November 6th, 2025

Attn: Travis Hertneky, PE; THEngineering, LLC

Project Name: Kiowa Creek Recycling Facility  
Case Number: USR25-001  
Parcel No.: 2067-00-0-00-372  
Variance Letter: #1

6 POND OUTLET DETAIL N.T.S.

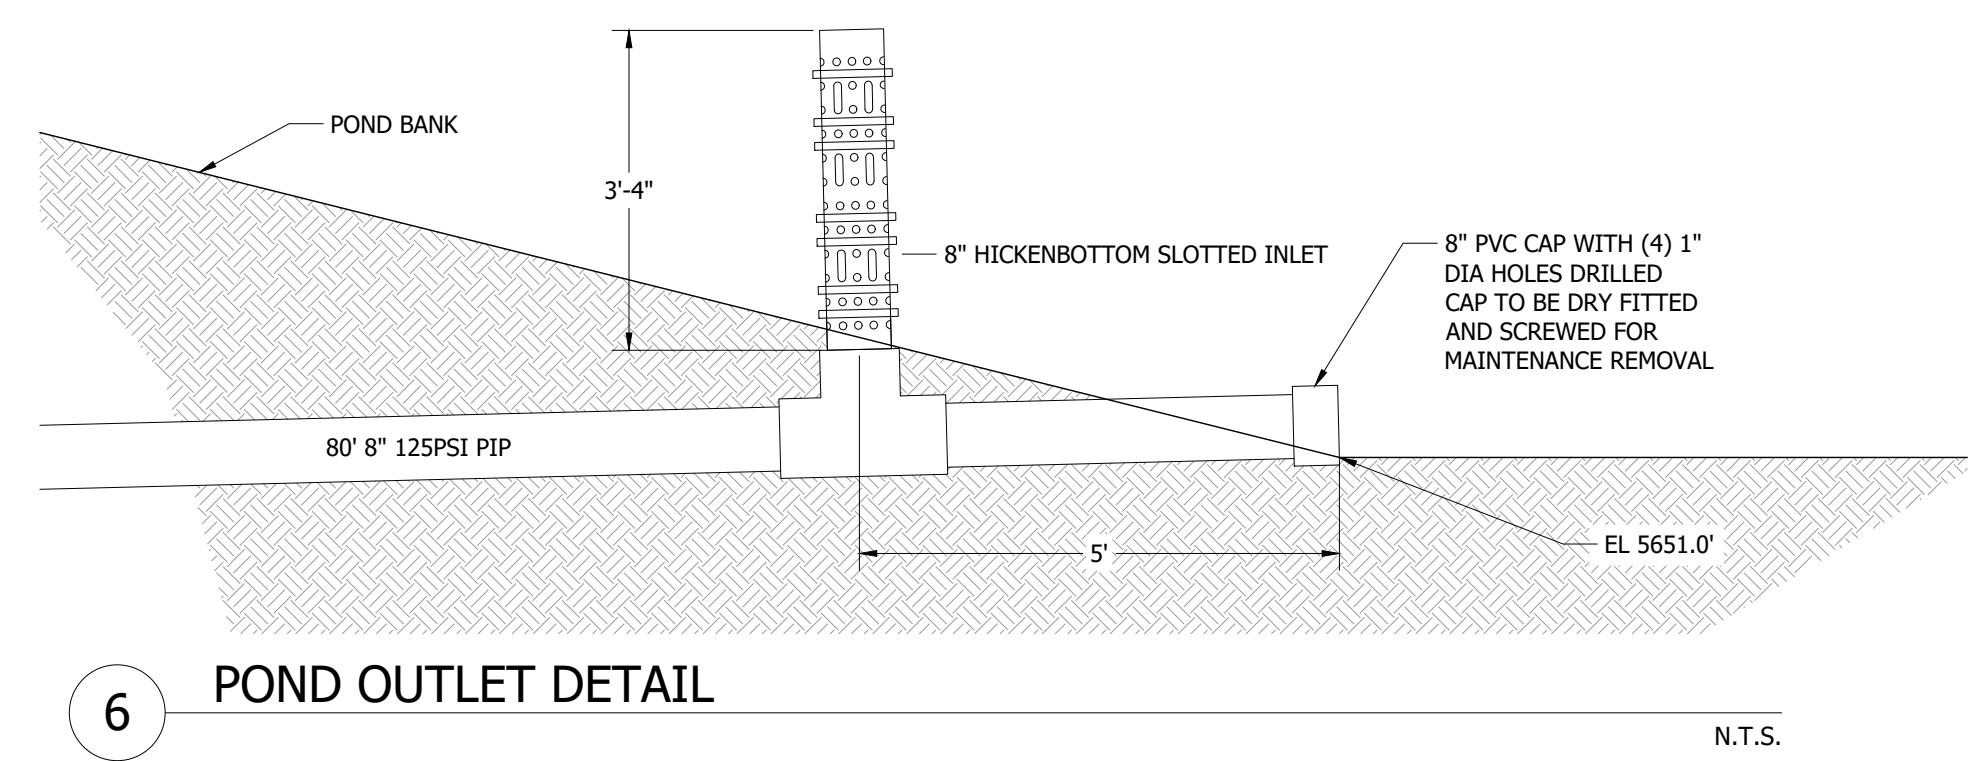
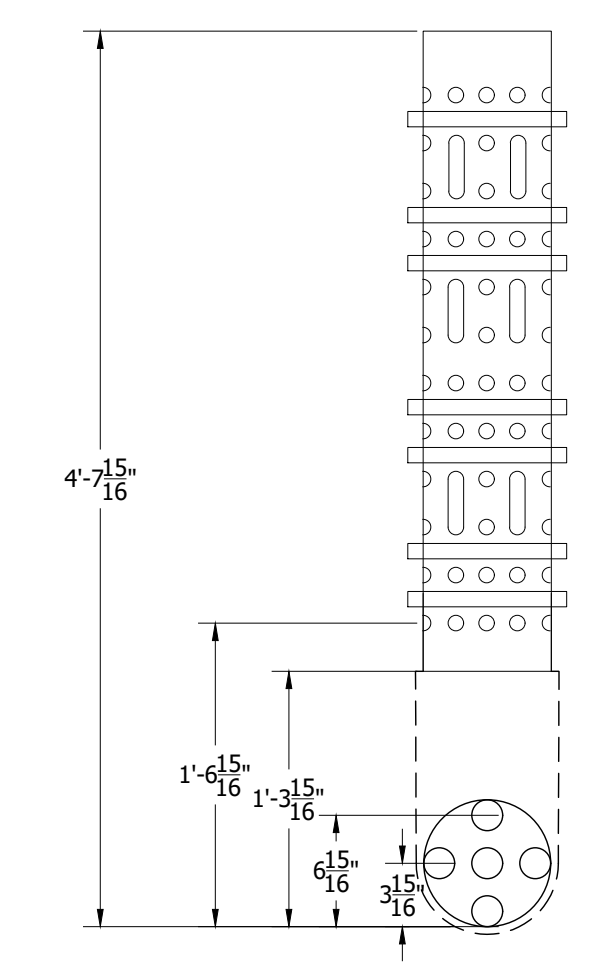
- a. Section 13.3.12 of the SMM requires that detention basin outlet structures shall be provided with oversized safety/debris grates and easy to maintain. Section 13.4.4 requires that the outlet configuration be designed in accordance with the criteria shown in Volume 3 of the Urban Storm Drainage Criteria Manual (USDCM). The applicant proposes a “Hickenbottom inlet” which consists of an 8” slotted PVC pipe in riser pipe configuration.

- a. This request is denied by the TRC. The proposed outlet structure appears to require significantly more maintenance than a standard concrete outlet structure and would be more likely to clog with smaller debris. It is the opinion of TRC that it has not been sufficiently demonstrated that there is a need for a variance from the standard outlet structure design criteria and requirements.

Hydraulic modeling of the outlet indicated that using orifice equations for all the riser orifices resulted in a flow which exceeded the capacity of the outlet pipe. For this reason the outlet structure was modeled by calculating the flow through the orifices on the end of the pipe using standard orifice equations. The

higher flows through the Hickenbottom inlet were modeled by assuming a large weir box with an 8" outlet with a restrictor plate fully open.

Gated pipe outlet restricts outfall to less than the historic 5yr rate but still drains 99% of the 100yr inflow from the basin in 58hrs. Basin is oversized to allow for option of future conversion to retention in the event of regulation change and thus the basin can hold the total projected runoff of the 100yr-1hr storm event of 3.128ac-ft or the 25yr-24hr storm event of 4.35ac-ft before overflowing the emergency spillway at 5.4ac-ft.
